RECEIVEDSTATE OF IDAHO
DEPARTMENT OF WATER RESOURCESTransfer No. 85688

APPLICATION FOR TRANSFER OF WATER RIGHT PART 1

RE: Transfer No. 85688
Water Right No(s). 23-88B

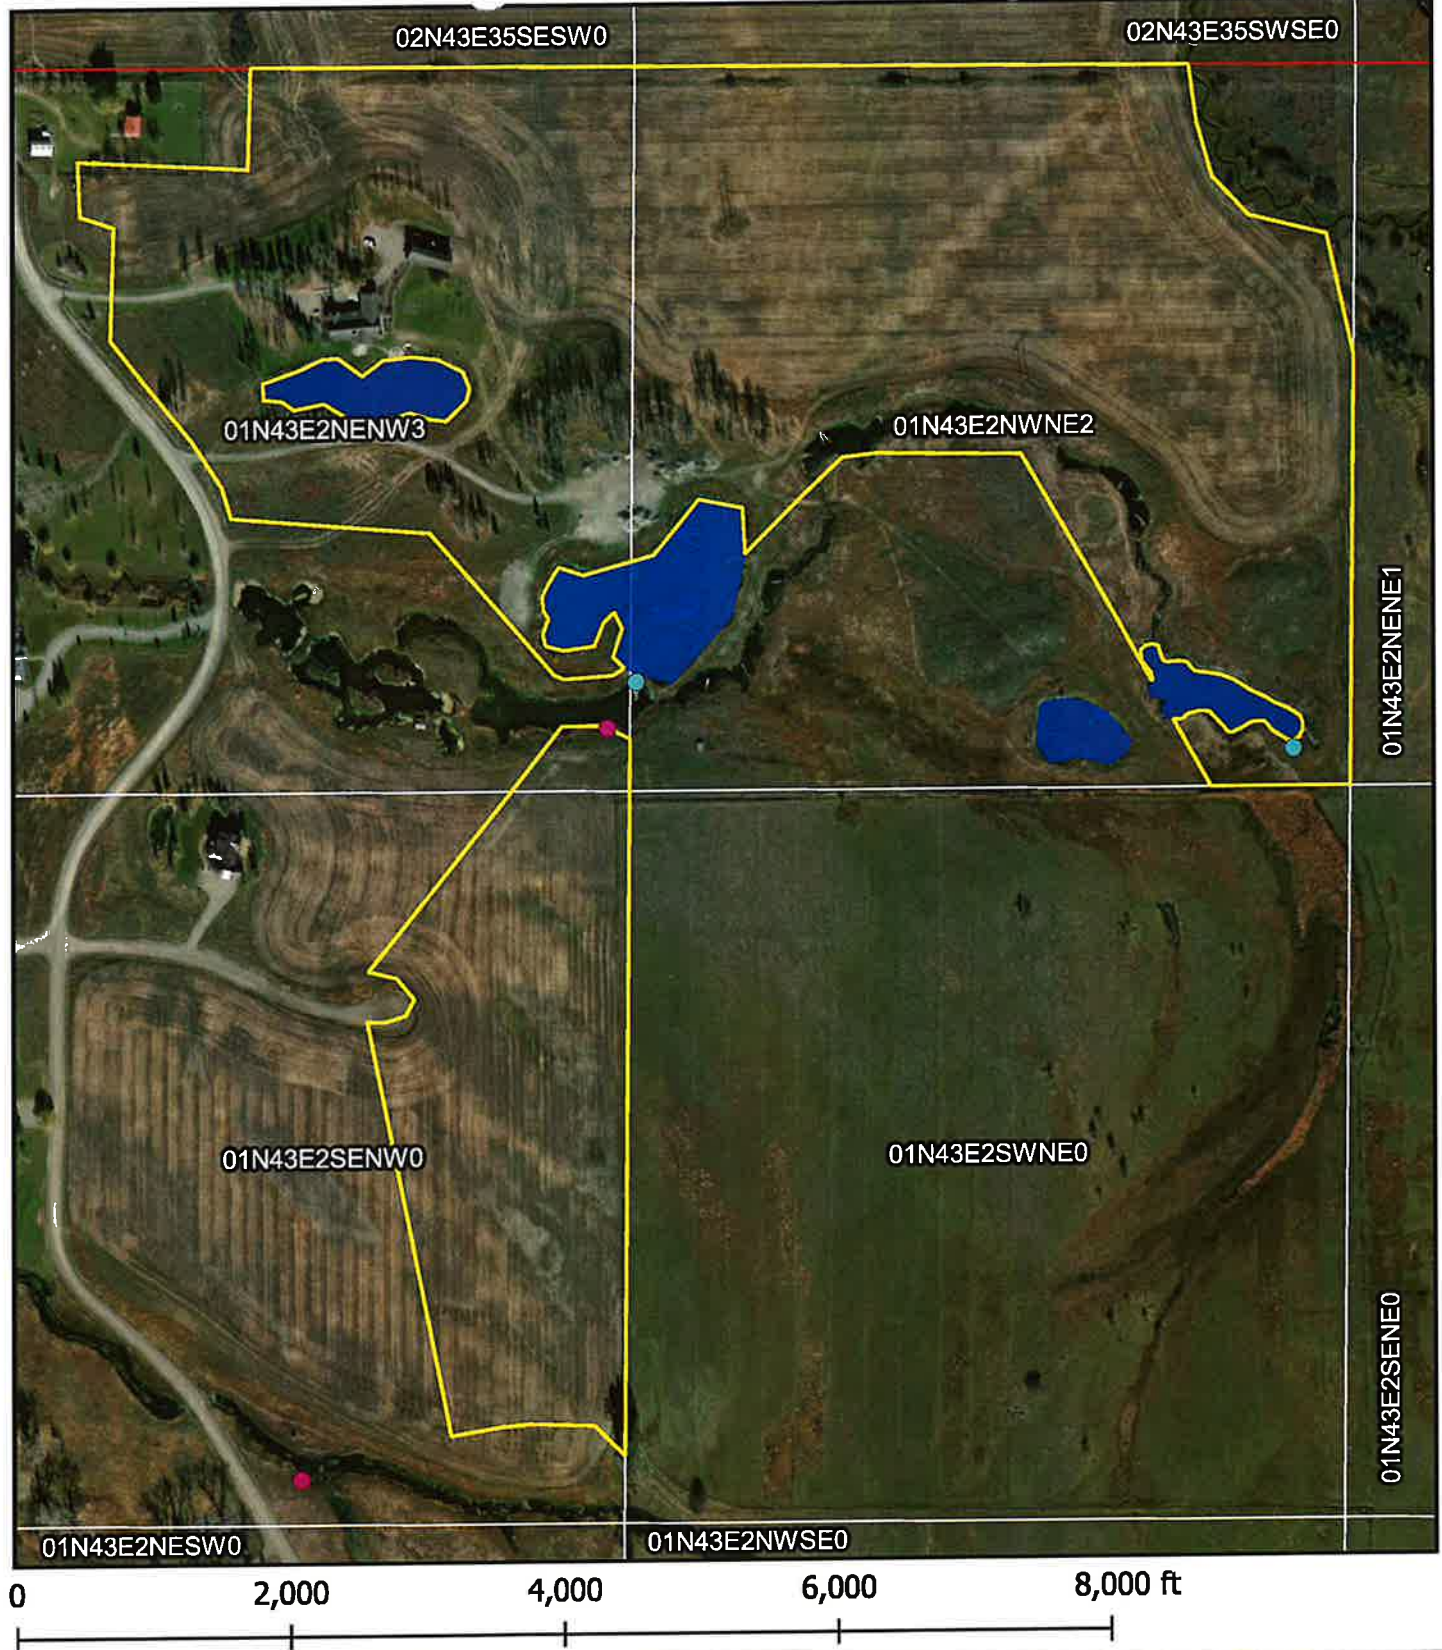
I have one more question. Pg. 3 of the transfer application involving WR 23-88B describes one new POD in the NWNE and the other in the NENW. However, based on the enclosed map, it looks like both PODs might be within the NWNE. The western-most new POD seems to be on the border, so I wanted to double check before I data entered.

The client had us adjust the POD based on his on-the-ground knowledge and we got the map right, but looks like Pg 3 didn't get updated. I've fixed that for you, too.
